On behalf of Clayton Properties Group LLC, CORE Consultants, Aztec, Fox Tuttle Transportation Group, and Terracina Design, we have reviewed the comments from the Second Submission Review for the Prairie Point Golf Site Plan. The following is a response to comments:

Second Submission Review

PRAIRIE POINT GOLF COURSE
AURORA, COLORADO
SITE PLAN
COVER

PRAIRIE POINT GOLF COURSE
AURORA, COLORADO
SITE PLAN
DETAILED STRUCTURE GRADING

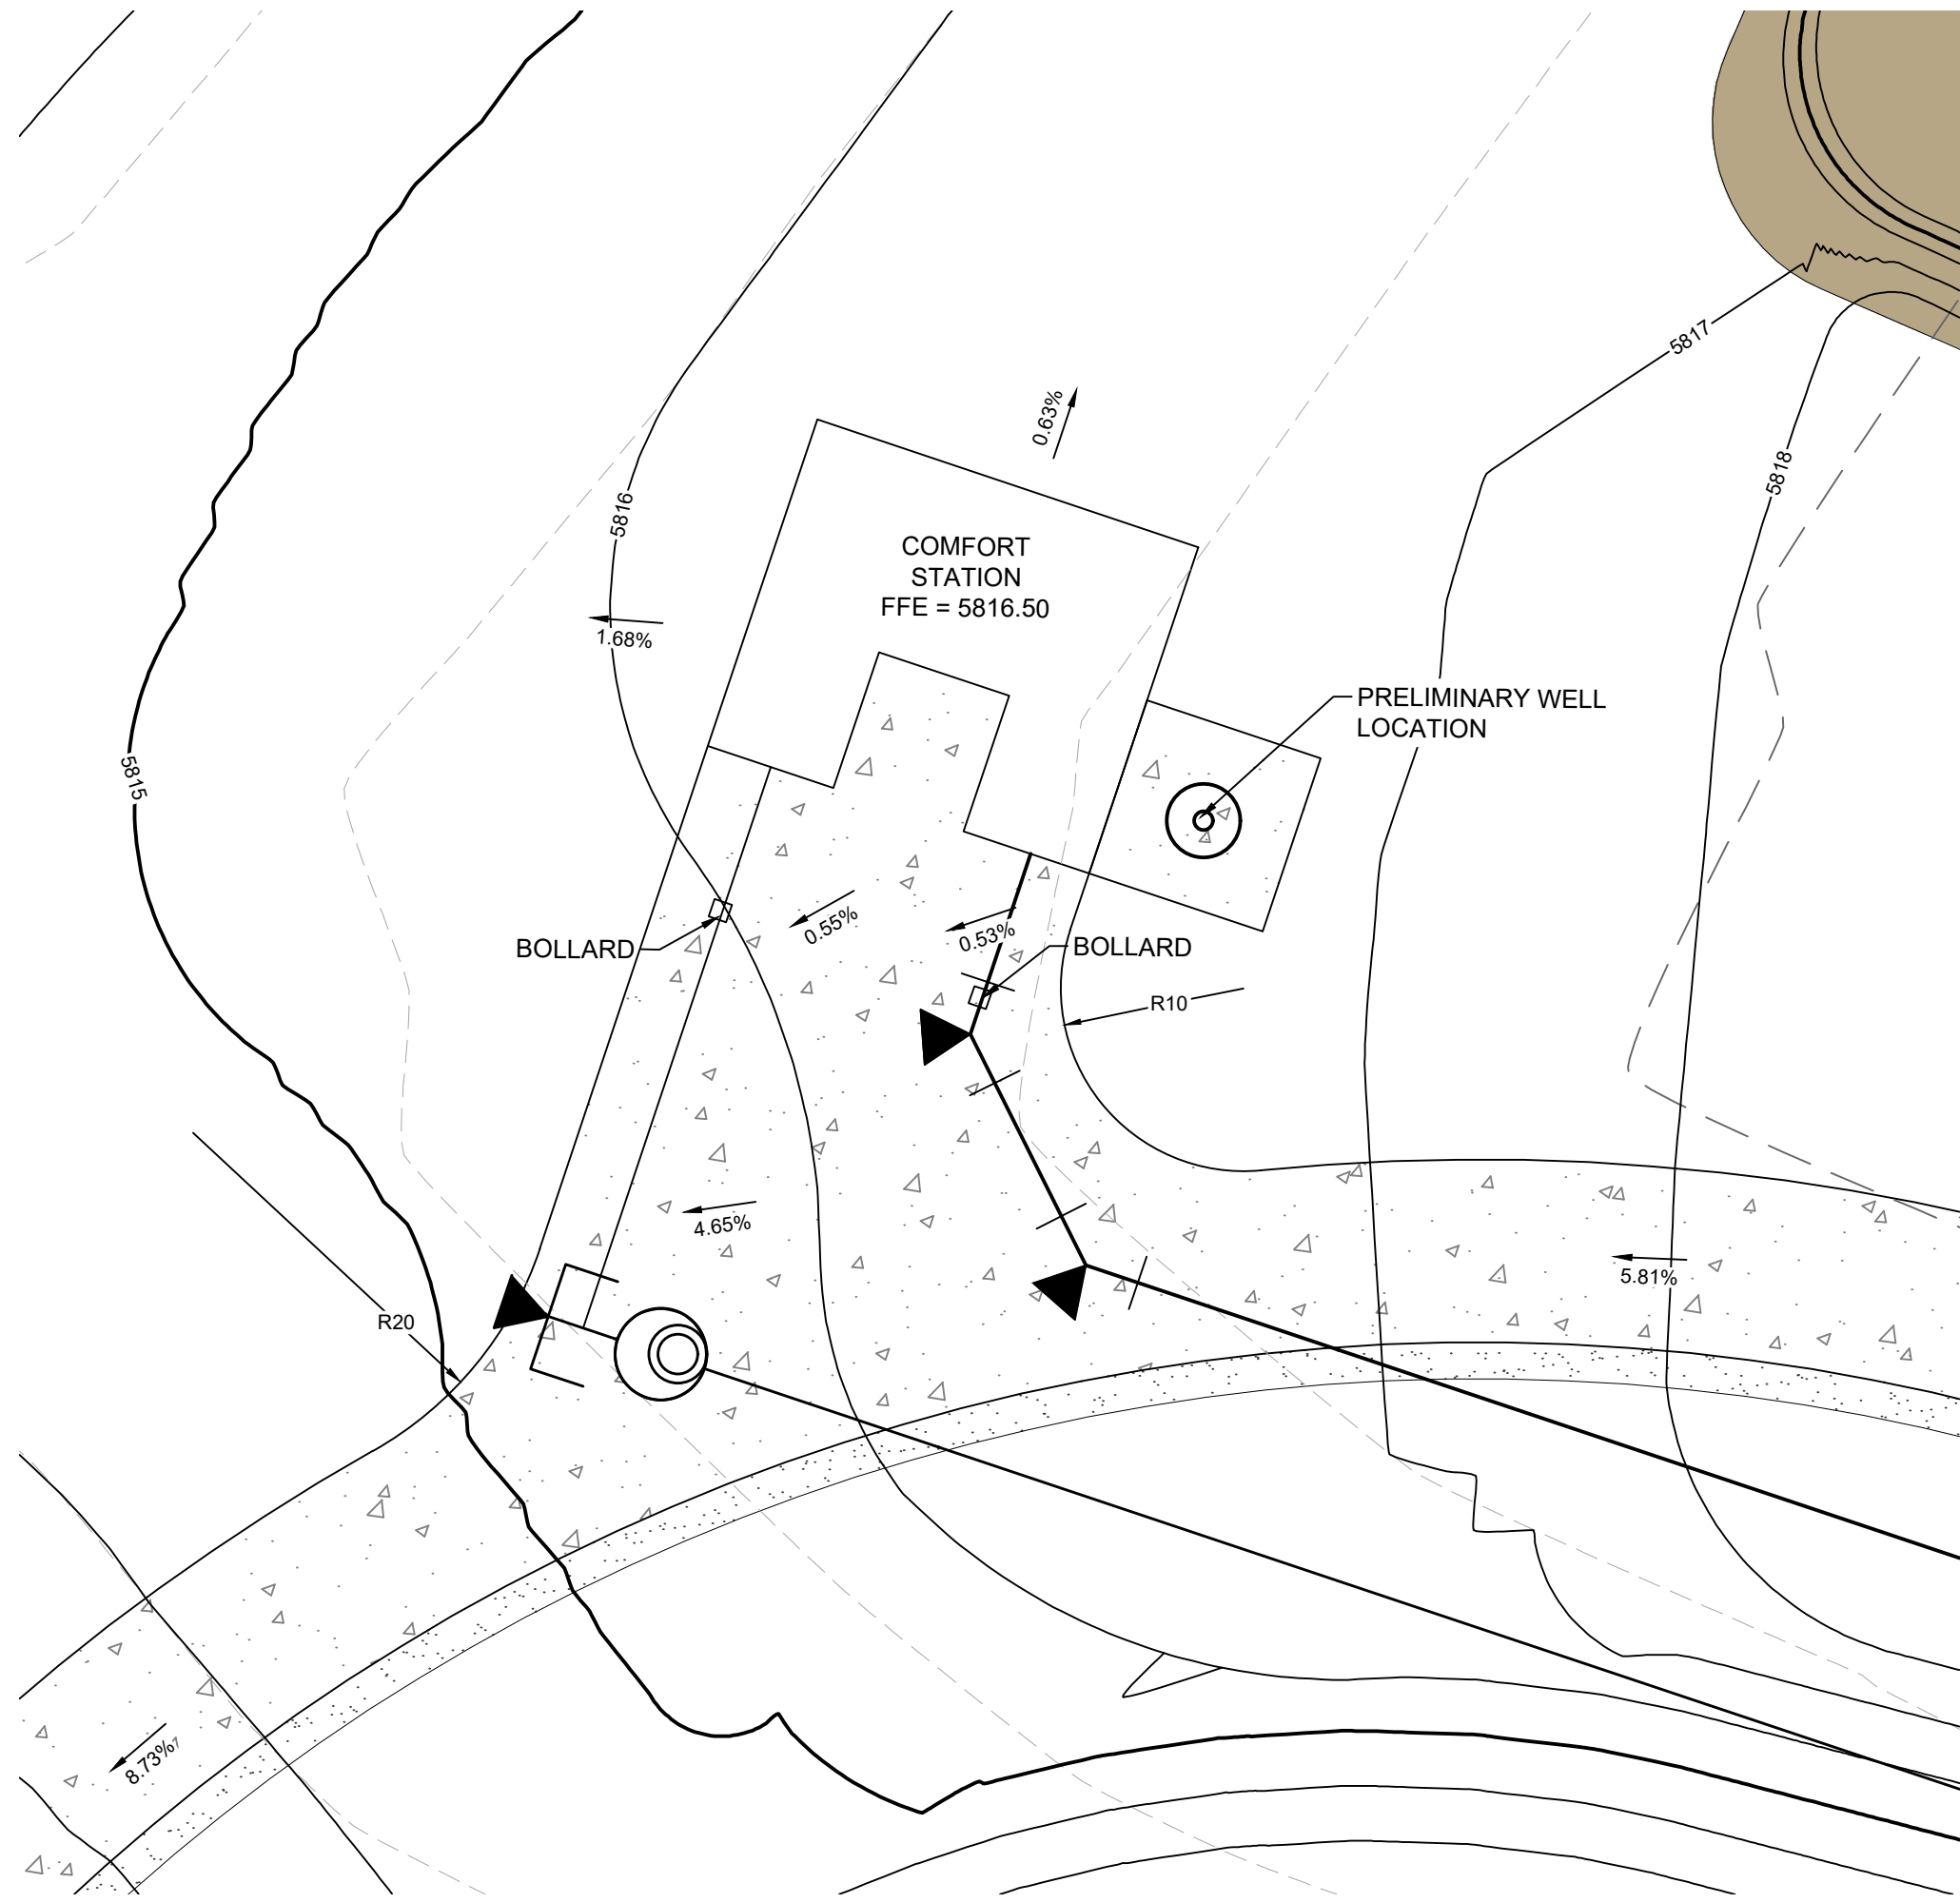
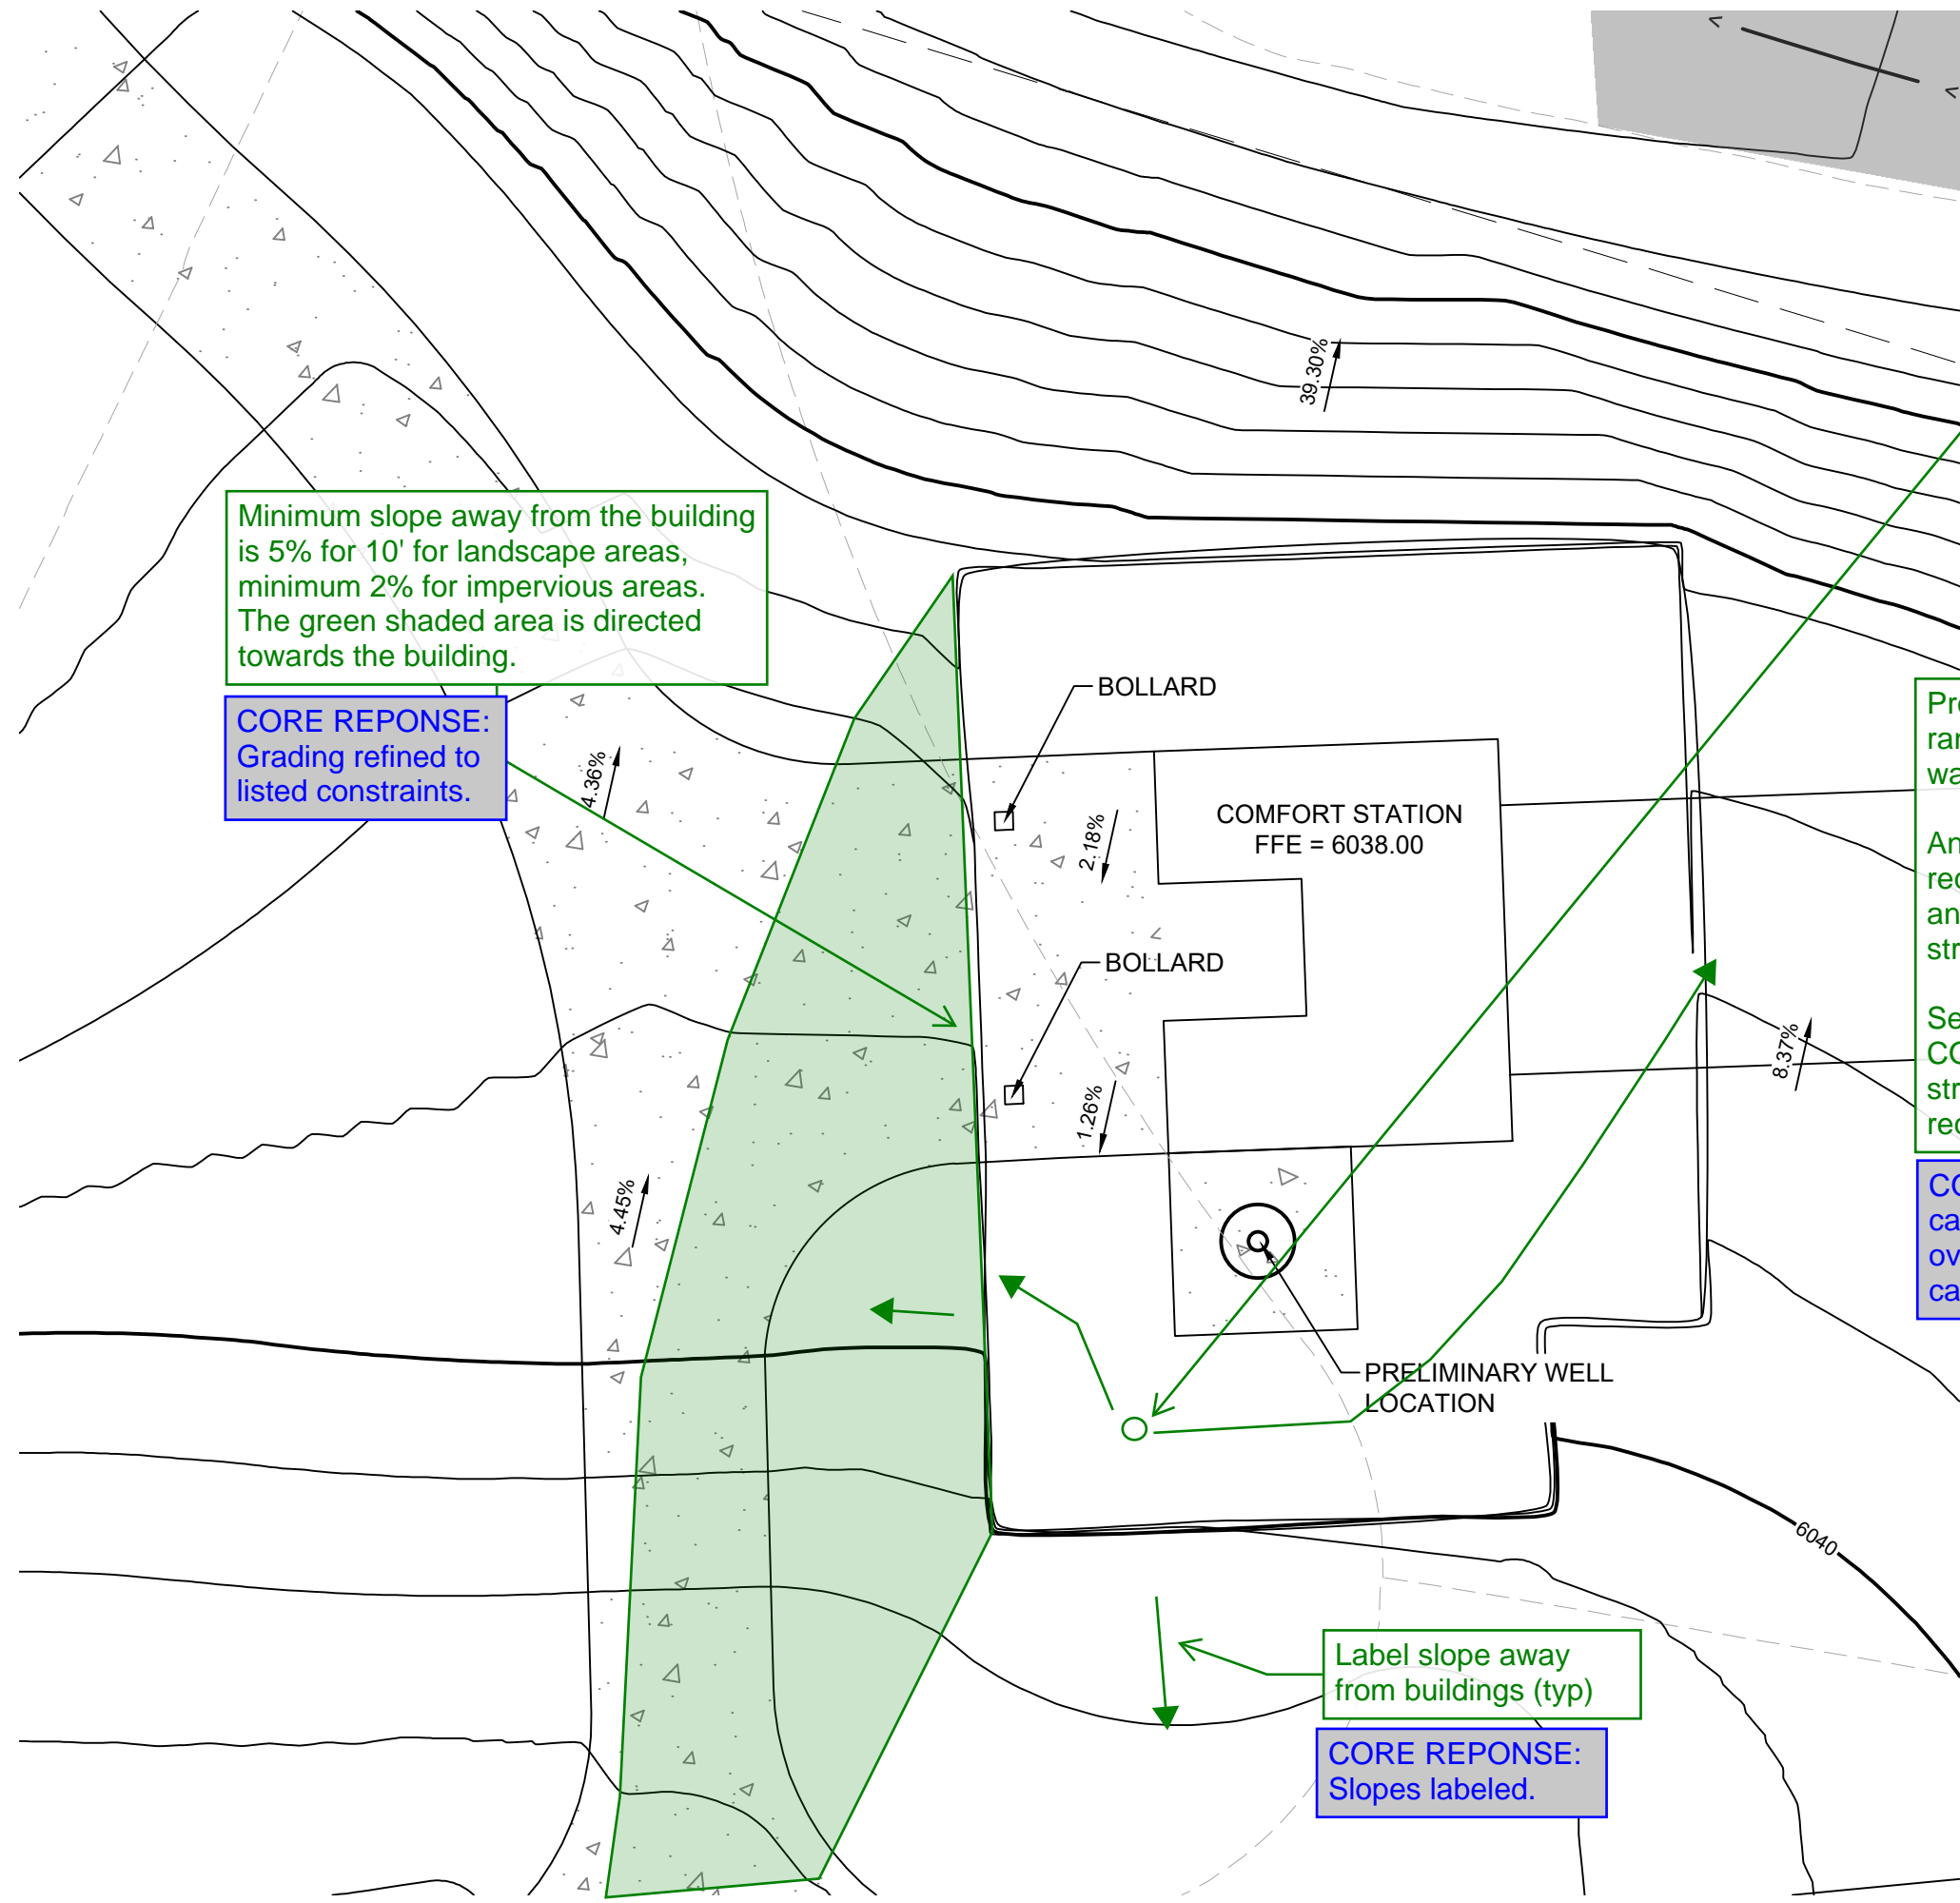
Provide a detailed grading sheet for the maintenance building showing longitudinal and transverse grade percentages through fire lane easement and accessible route.

Provide a high point and swale around buildings.

Provide the max height or height range for the proposed retaining walls.

Minimum slope away from the building is 5% for 10' for landscape areas, minimum 2% for impervious areas. The green shaded area is directed towards the building.

Label slope away from buildings (typ)

CORE REPOSE: Slope labels added to site plan sheet showing maintenance building.

CORE REPOSE: Railings called out for all wall sections over 30". Approximate heights called out at bends in wall.

CORE REPOSE: Grading refined to listed constraints.
